Subject: Virgil C. Summer Nuclear Station (VCSNS) Units 2 and 3 Combined License Application (COLA) - Docket Numbers 52-027 and 52-028 Response to NRC Request for Additional Information (RAI) Letter No. 043

**NRC RAI Letter No. 043 Dated April 7, 2009**

**SRP Section: 2.4.2 – Floods**

**NRC RAI Number: 02.04.02-1**

RAI 02.04.02-1 Figure 1: Location of Supercritical Flow Region  
 (Modified from FSAR Figure 2.4-210)

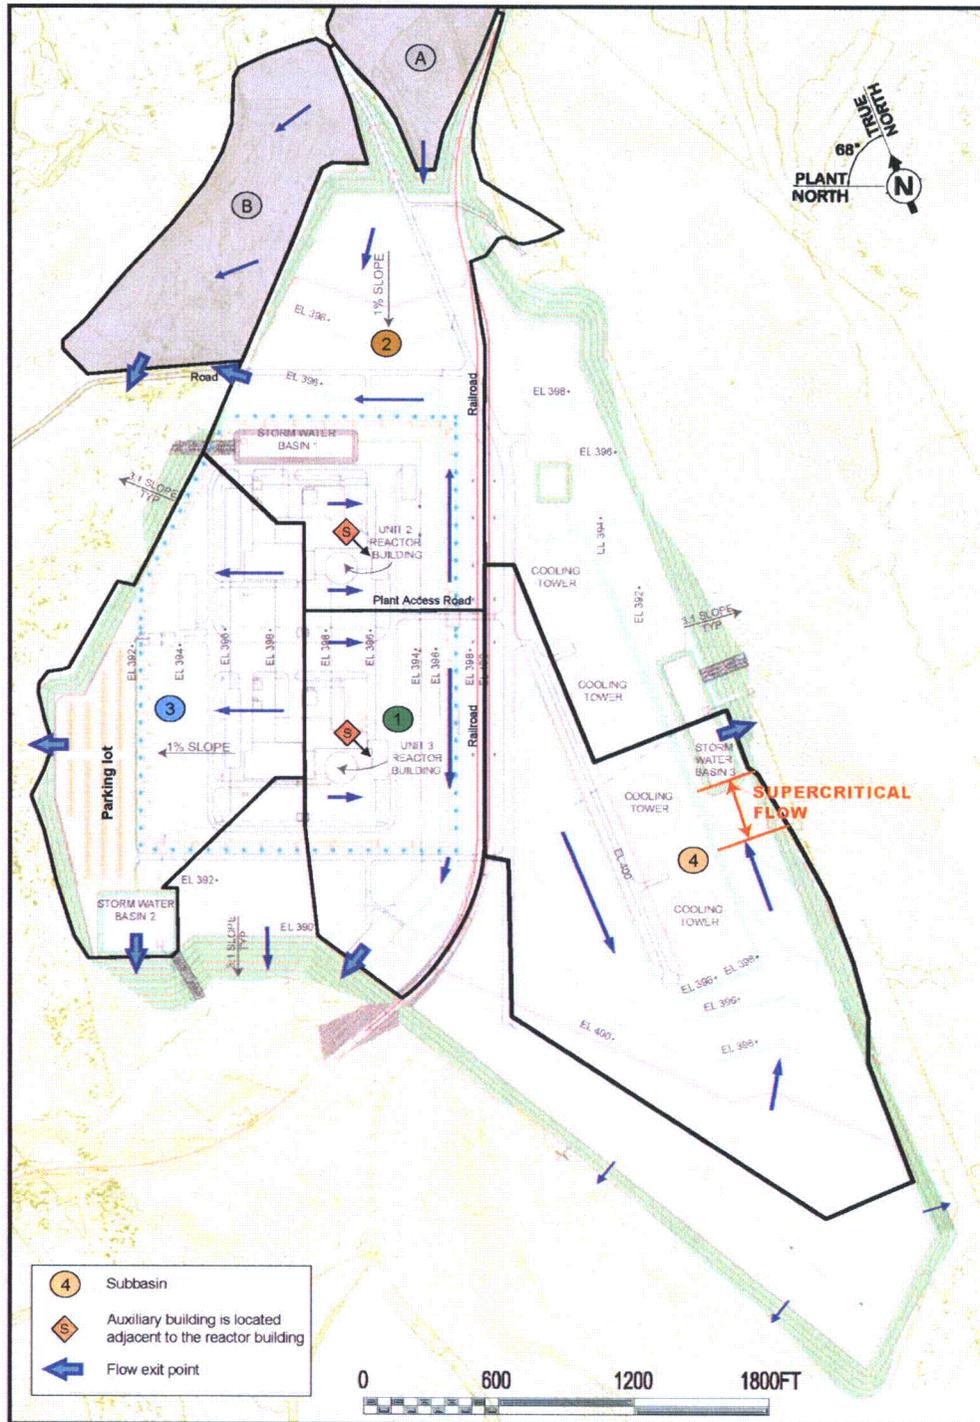
- Clearly identify locations where supercritical flows are likely to occur in ditches, channels, and associated overland-flow areas. Also indicate locations where PMP-generated flood events produce velocities significantly larger than the design velocity for the channel bed material (i.e., where damage exceeding normal maintenance would result). For these locations, describe how failure of these drainage features will not degrade any structures related to safety.

- Clearly identify locations where hydraulic jumps are likely to form during the flooding event and provide a description of fortification measures to ensure that hydraulic forces induced by the jumps do not erode or degrade the ditches, channels, and overland flow areas. If the hydraulic structures are expected to fail during the PMP-generated flood event, provide a description describing how failure will not degrade any structures related to safety.

- A. RAI 02.04.02-1 Figure 1 depicts the location within the site where a supercritical flow condition may occur. The area identified is the steep reach just upstream of the Storm Water Basin 3, which is outside the power block area (i.e. protected area) of Units 2 and 3 where the safety-related SSCs are located.

The peak flow velocities in the drainage paths of all the subbasins modeled, with the exception of the channel reach with supercritical flow condition, are smaller than 5 ft/s. Typical protection measures such as grass lining or gravel cover on the drainage channels and on the yard areas subject to sheet flow conditions are sufficient to withstand these small erosive forces. In the channel reach identified with potential supercritical flow conditions, the peak velocity is estimated to be about 11.8 ft/s. Properly sized and placed rip rap channel linings are able to withstand these velocities and greater (Reference 1).

The other areas that supercritical flow conditions may occur are on the natural hill slopes and the fill slopes at and downstream of the locations where storm water runoff is postulated to flow out of the site. These areas are shown as "Flow Exit Point" in Figure 1. These potential overflow areas will be protected by riprap or concrete structures designed to prevent a failure of the drainage features of the site and preclude degradation of any safety-related SSCs.

- B. A hydraulic jump may potentially form in the transition area where the drainage swale with supercritical flow enters the Storm Water Basin 3. The inlet to the Storm Water Basin 3 will be protected by riprap or concrete lining, designed to withstand the scouring effects associated with energy dissipations at the transition. This area is at a distance of over 1000 ft from the safety-related SSCs, sufficiently far away that it will not pose any risk to the safe functioning of the plant in the unlikely event that the drainage structures were to fail.
